## INSTALLATION INSTRUCTIONS

Model: 10/15/20REOD/REOZD and 20REOZDT Generator Sets Market: Industrial Subject: Battery Access Door Service Kit GM40633

Figure 2 Battery Access Door (battery/starter side of generator set shown)

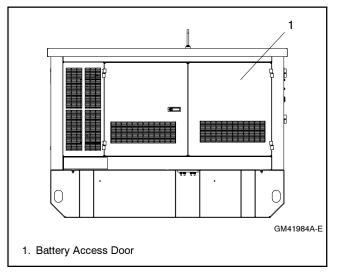
The battery originally recommended for models 10/15/20REOD/REOZD and 20REOZDT is no longer available. See Figure 1. Replacement battery 256985 is taller than original battery 324367 and requires a change to the ductwork on the enclosure's battery access door.

Enclosed and towable generator sets with serial numbers before 2089661 require a change in the ductwork on the battery access door when the battery is replaced. See Figure 2. Install service kit GM40633 to change the ductwork on the enclosure's battery access door.

Models with serial numbers 2089661 and above are factory-equipped with the updated door and do not require the service kit.

Figure 3 Battery Door Duct

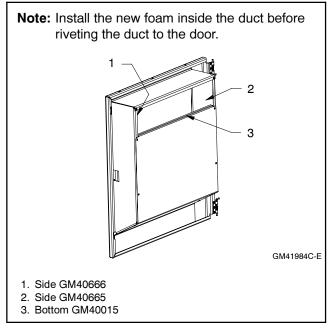
- 4. Remove the battery access door (left side, rear of the enclosure).
- Drill out the rivets located at the top corners of the duct and at the bottom edge of the door. See Figure 3. The top panel of the duct will be reused.

- 6. Remove the existing side and bottom duct panels.
- 7. Remove metal chips and clean metal surfaces before assembly.
- 8. Assemble the right side (GM40629), left side (GM40628), and bottom (GM40627) duct panels using 8 rivets, X-781-19. See Figure 3.
